**CONDITIONAL APPROVAL
PLAN APPROVAL EXPIRES: 08/30/2018**

Western Lime & Cement
N4520 Cty Rd V
Village of Eden, 53019
Fond Du Lac County

Facility: 585663 WESTERN LIME & CEMENT
N4520 CTY RD V
EDEN 53019
Plan Type: Addition-Alteration; 1 Interior Fixture(s)

Object Type: Commercial Water Treatment Device Regulated Object ID No.: 1614201

GRAYMONT Arsenic Reduction System P&ID			
DWG Reference:			
Site Specific Graymont -			
6/28/2016			
DWG : A. Mast			
BY :			
Engineering Approval	: A. MAST

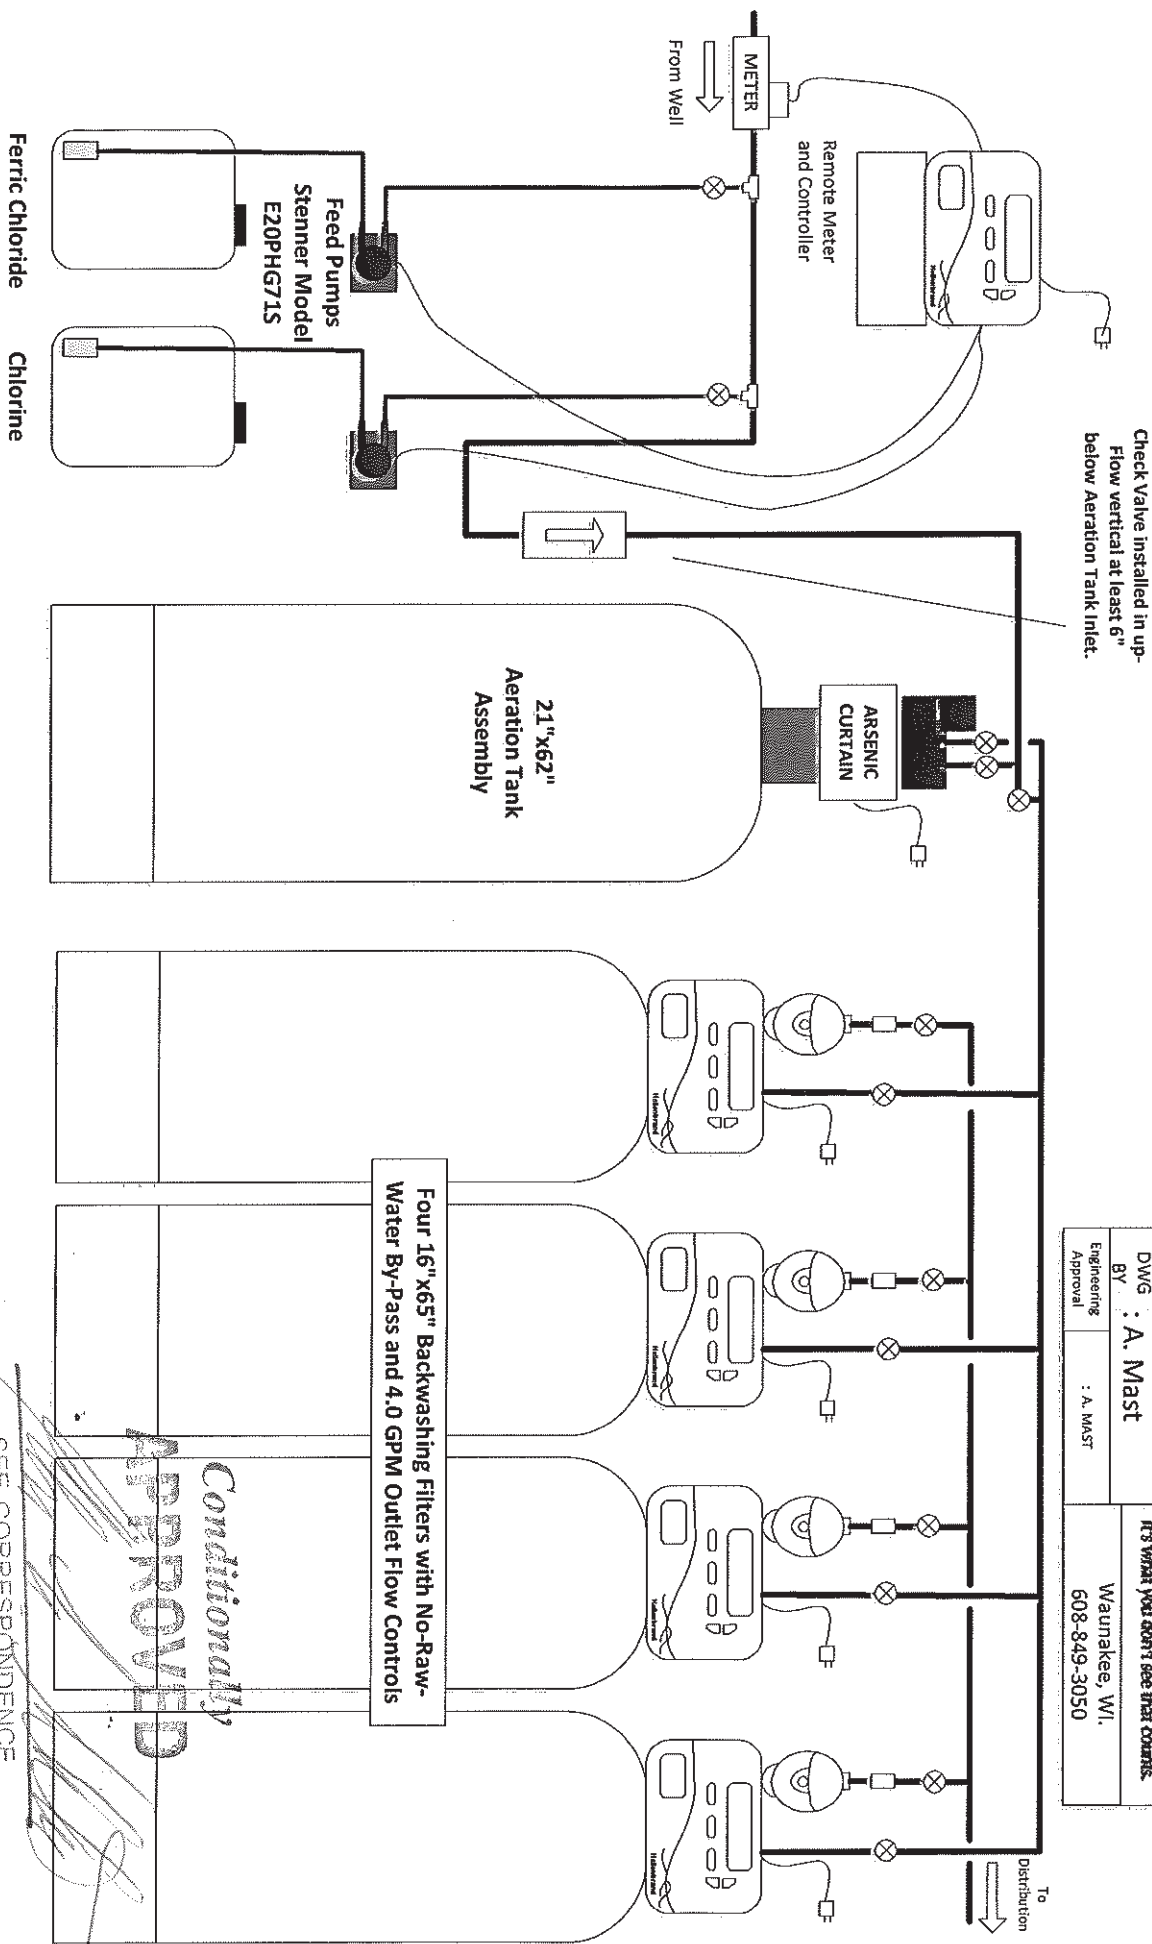
- No bypass piping shall be installed serving the arsenic reduction device.
- Any wall hydrant that is not served by these arsenic treatment devices must have one, or more, of the following:
 1. The handles of the hydrant shall be removed;
 2. The hydrant shall be capped and sealed using solder; or
 3. Signage shall be posted immediately above the hydrant indicating the water is unfit for human consumption
- All potable water distal outlets not served by the arsenic reduction system, other than water closets/urinals shall display acceptable signage indicating the water is unfit for human consumption.
- All water distribution piping shall be marked as required by Table SPS 382.40-1a.

- If the water supply piping is used as an electrical ground, then properly sized electrical bonding jumpers must be installed to maintain the electrical continuity of the path to ground that is interrupted by the installation of plastic (i.e. insulating) water treatment device control valves.
- The treatment system to be installed is the AC-16 quad-plex parallel arsenic reduction system:

- Any chemicals injected into the potable water supply must conform with ANSI/NSF Standard 61 and be used at, or below, the specified maximum use concentration.

- The chemicals shall be introduced via approved positive displacement chemical feed pumps, specifically the Stenner E20PHG71S.
- Flow controls shall be installed to preclude the arsenic reduction device from exceeding its maximum rated service flow rate of 16.0 gpm.
- The existing onsite drain, waste and vent piping must be properly sized to accept the additional load of the regenerative effluents of the water treatment devices being installed.
- The finished installation must undergo a final inspection prior to the treated water being used for consumptive purposes. The Plumbing Consultant having jurisdiction in this area is Phil Mnuk. Mr. Mnuk can be reached via the following:
